**EXTRACT FROM COUNCIL MEETING MINUTES OF SEPTEMBER 17, 2013**

**4                                ZONING BY-LAW AMENDMENT FILE Z.13.016**  
**FRANK HOZJAN**  
**WARD 5 – CENTRE STREET AND DONNA MAE CRESCENT**

**4.      ZONING BY-LAW AMENDMENT FILE Z.13.016**

# Conceptual Site Plan and Proposed Land Severance

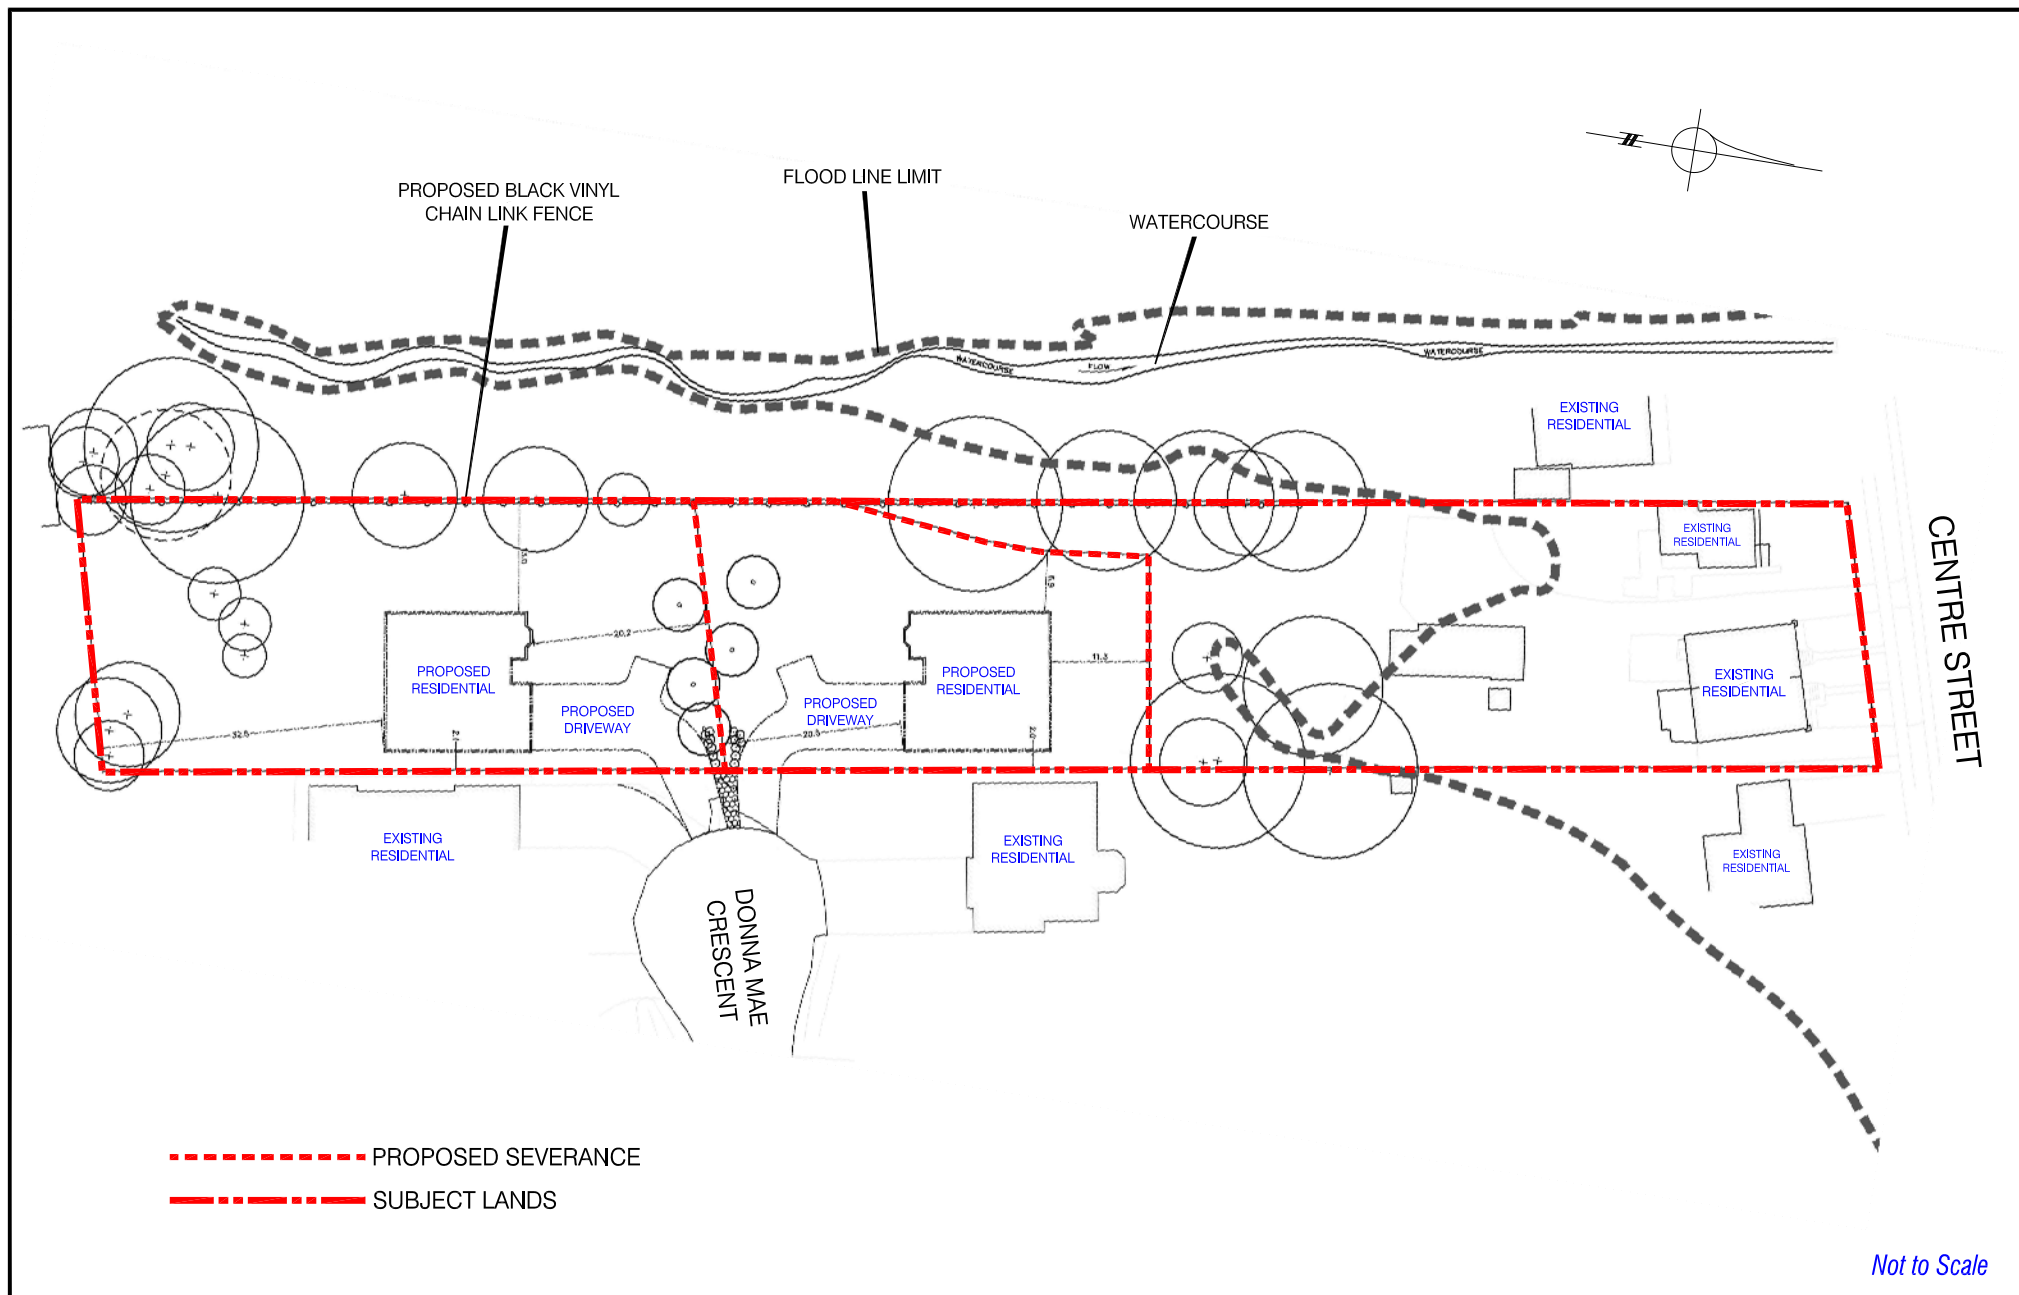
b.	Appropriateness of Proposed Development, and Site-Specific Zoning Exceptions	<ul style="list-style-type: none"> <li>▪ The appropriateness of amending Zoning By-law 1-88 to facilitate a future severance of the subject lands to create two new lots for single detached dwelling units as shown on Attachments #3 and #4, together with site-specific zoning exceptions for the retained and severed lands will be reviewed in consideration of the surrounding land use context.</li> </ul>

g.	Location and Grade of Proposed Driveways	<ul style="list-style-type: none"> <li>▪ The appropriateness of the proposed location and grading of the two driveways at the existing terminus of Donna Mae Crescent will be reviewed by the Vaughan Development/Transportation Engineering Department and the Vaughan Building Standards Department.</li> <li>▪ Zoning By-law 1-88 requires all driveways to have a positive slope away from all parts of the building or structure to the street for single detached dwelling units, which will be reviewed.</li> </ul>

h.	Frontage on a Public Street and Improvements to Donna Mae Crescent	<ul style="list-style-type: none"> <li>▪ The proposed lots currently do not have frontage on a public street. A 0.3 m reserve (Part 8 on 65R-6509) is located adjacent to Donna Mae Crescent and must be lifted prior to the creation of the proposed lots.</li> <li>▪ Road improvements to Donna Mae Crescent that are required to facilitate driveway access to the proposed lots will be reviewed and identified. The Owner must satisfy all road requirements of the Vaughan Development/Transportation Engineering Department.</li> </ul>

i.	Future Consent Application	<ul style="list-style-type: none"> <li>▪ Should Vaughan Council find merit in the subject zoning application, the Owner must submit a Consent application to the Vaughan Committee of Adjustment to permit the severance shown on Attachment #3 to create 2 new residential lots for two single detached dwelling units.</li> </ul>
